Sub Forest (Conservation) Act, 1980 – Online forest clearance proposal for diversion of 0.90 ha of forest land in Ponnaiyar RF for construction of fuse plug pertaining to Thandampattu Taluk in Tiruvannamalai District furnished to the Government of India – Minutes of the meeting conducted by the IRO Chennai with the user agency on 21.11.2022 communicated – sending of - Regarding.

Site Inspection Report of S Sasikumar IFS, Deputy Inspector General of
Forests (Central), Integrated Regional Office, Chennai

Proposal No: FP/TN/IRRIG/118339/2021

Name of the Project: Diversion of 0.90 ha of forest land in Pennaiyar RF in Tiruvannamalai Forest Division area for construction of fuse plug pertaining to Thandarampattu Taluk of Tiruvannamalai District for discharge of heavy floods from Sathanur Reservoir in Tiruvannamalai District in favour of Assistant Executive Engineer, PWD, Sathanur Dam, Tiruvannamalai District.

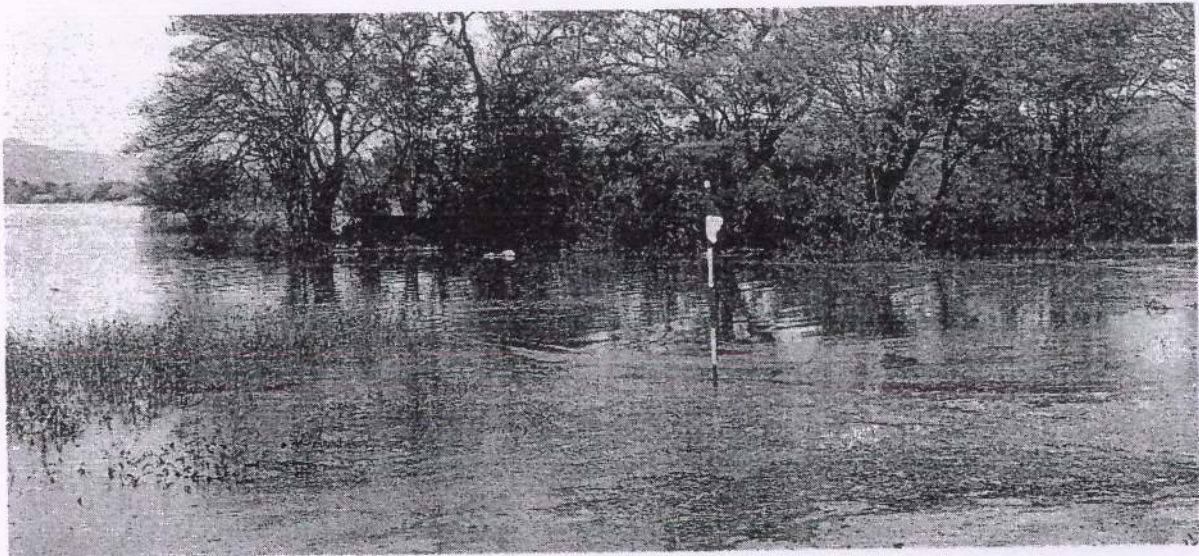
It is discussed and understood that no submergence has happened at this FRL. However, **what would happen at PMF, needs to be studied**. It is said that the structure of fuse plug would be made up of sand, gravel and a few portions only RCC. The diagram showing the cross section of RCC is submitted as **annexure-V**.

Annexure-III

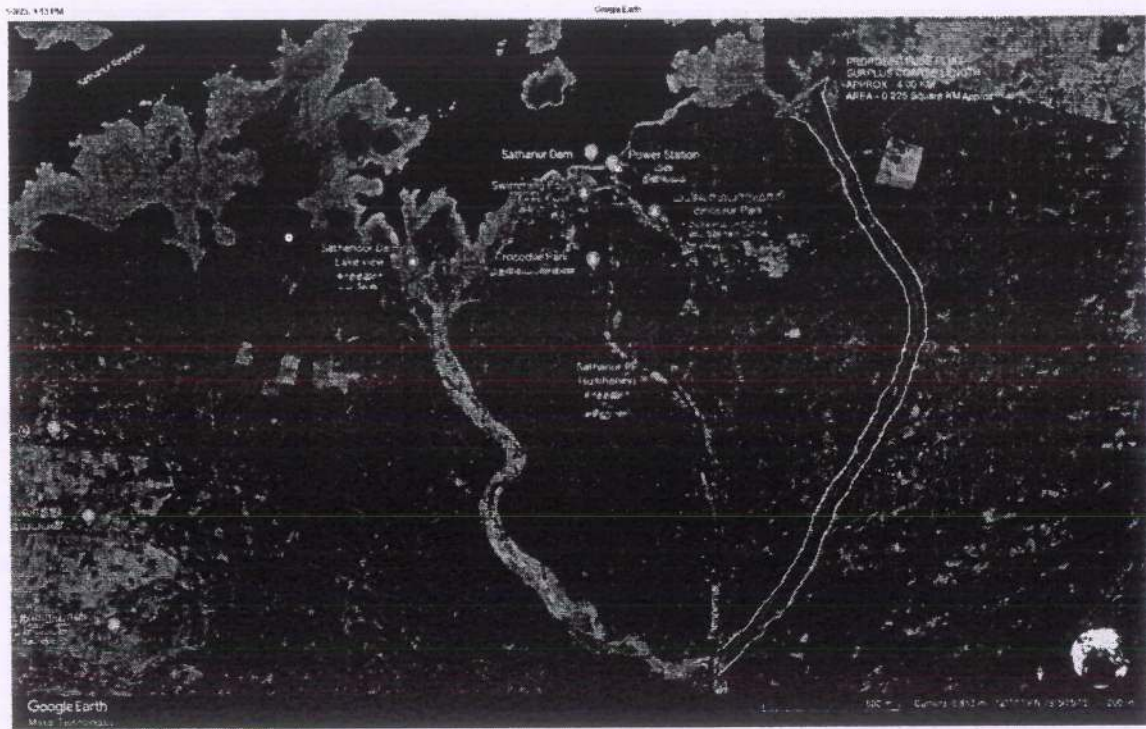
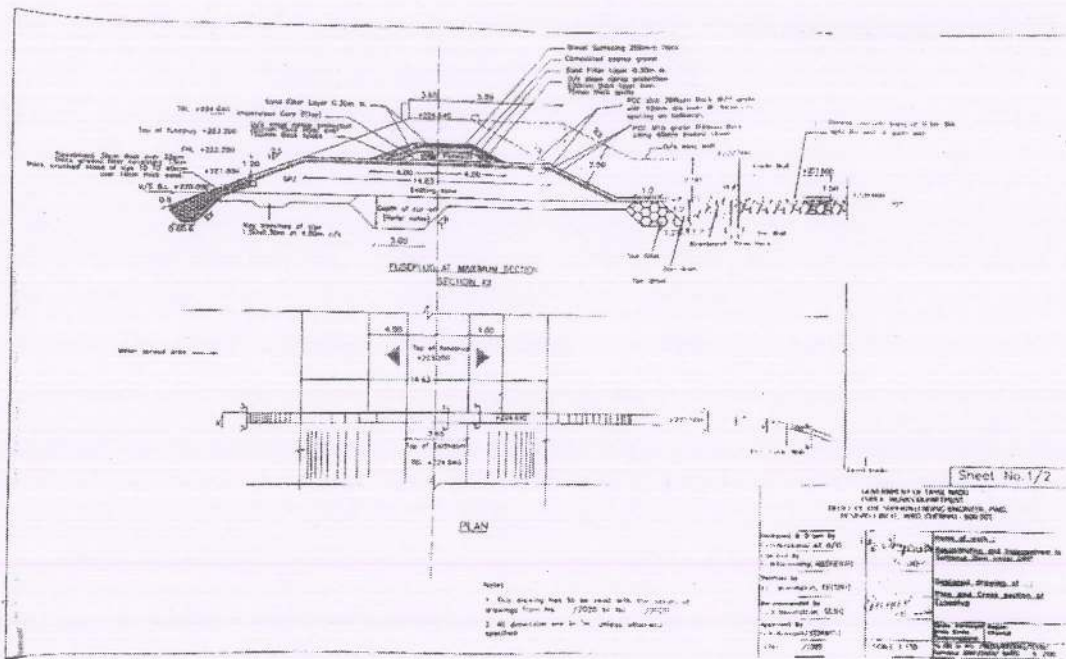
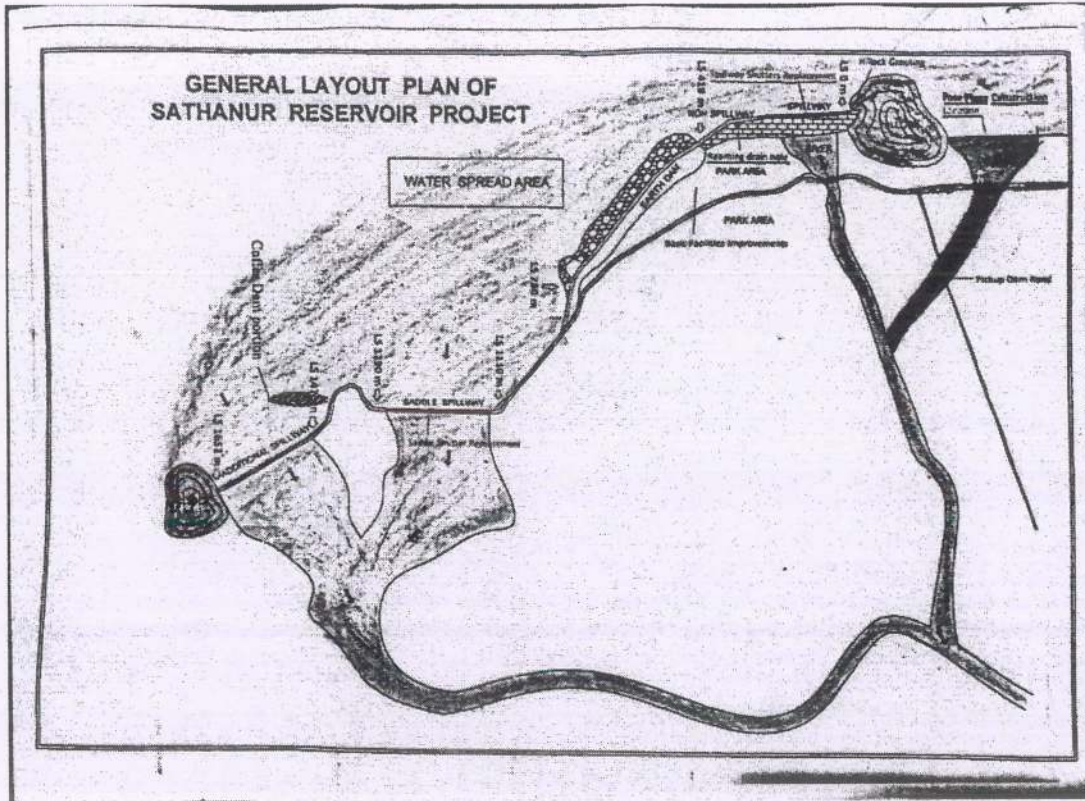
During the visit, it is seen that the dam is at full reservoir level (FRL). The water is seen to be leaking out of the dam through the natural gradient from the proposed site for construction of Fuse Plug. Photos showing the spill of water from the dam is submitted as **annexure-III**. And it is also seen that the water is being overflowing from the existing spillway, saddle and other outlets. At present there is no proposal from the User Agency to construct any channel to divert or connect this excess water to the main river. If it is allowed to go through the natural gradient and also through the existing walk way, it might cause huge damage to the trees present in the RF area. We may have to seek opinion from the State Government on this issue of excess water causing damage to the existing trees in the RF area. There is no contingency plan either proposed or submitted along with the proposal.

Water is at present over flowing from the propose fuse plug area. The dam is at full capacity

Annexure-IV

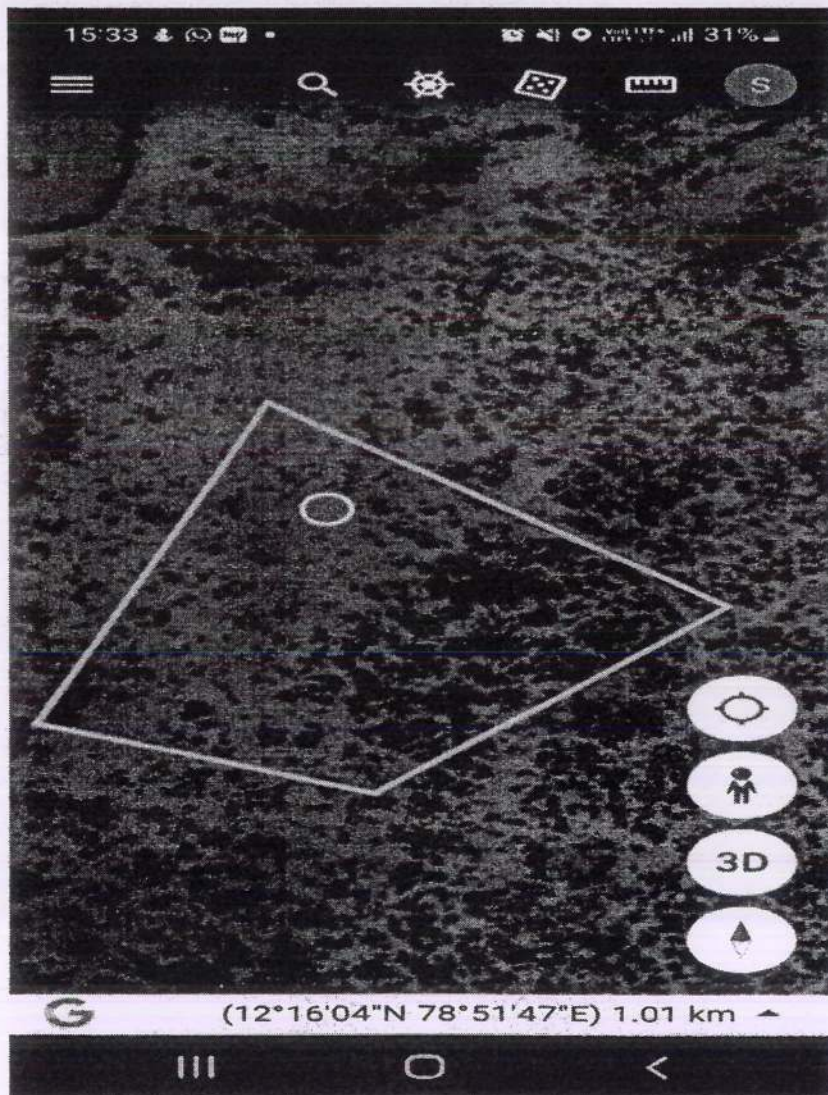
It is also seen that to connect such overflow water to the main stream, as such no canal can be constructed freshly, since, in the event of Probable Maximum Flood, where in around value of 21181 m³ /Sec. (748000 Cusecs) of water would be expected to be discharged. It is very difficult to regulate such a huge volume of discharge. A tentative

-128-
pathway, worked out based on the gradient, through which the excess water is expected to be discharged is shown on Google map is submitted as **annexure-IV**. The area which is going to be affected due to this voluminous discharge needs to be worked out and the expected damage to the trees in RF need to be worked out.
